MILITARY SPECIFICATION SHEET

BATTERY, RECHARGEABLE, NICKEL-CADMIUM, VENTED, AIRCRAFT,
BB-716/A, LOW CAPACITY CELL

This amendment forms a part of MIL-B-49450/6(ER), dated 16 January 1987, and is approved for use within the Laboratory Command, Department of the Army and is approved by all Department and Agencies of the Department of Defense.

Delete figure 2 and substitute the following:

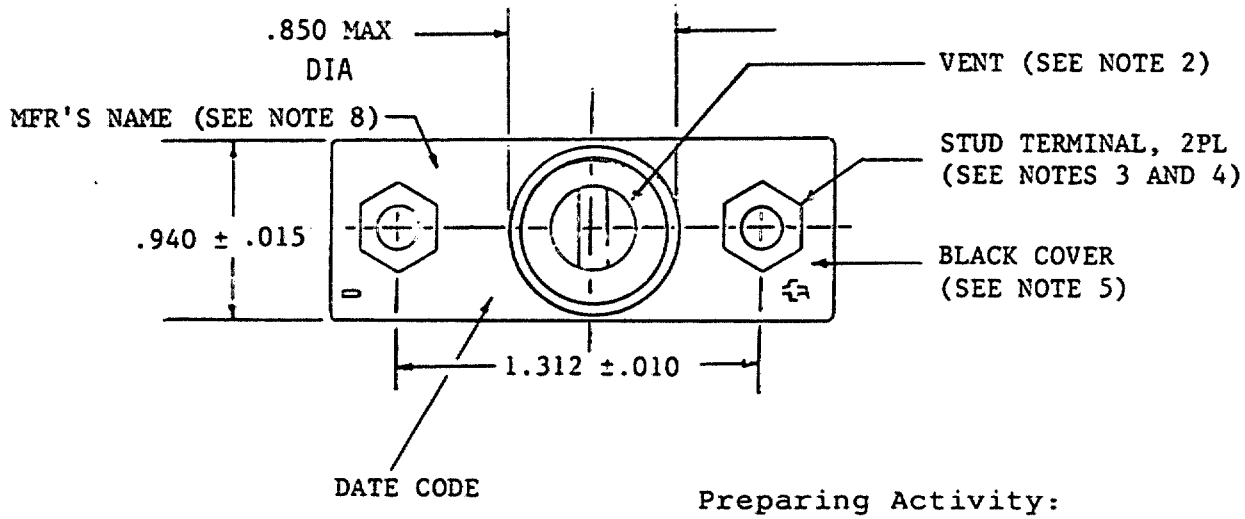
Drawing Note 5, delete in its entirety and substitute:
"5. The entire cell top shall be permanently dyed black."

Add the following Drawing Notes:
"7. Baffle position shall be located such that the requirements of 3.4.9.2 are met.

8. The manufacturer's name or symbol shall be added to the cell cover as shown by embossing or equivalent. Letter size shall be 3/32 ± 1/32 inch."
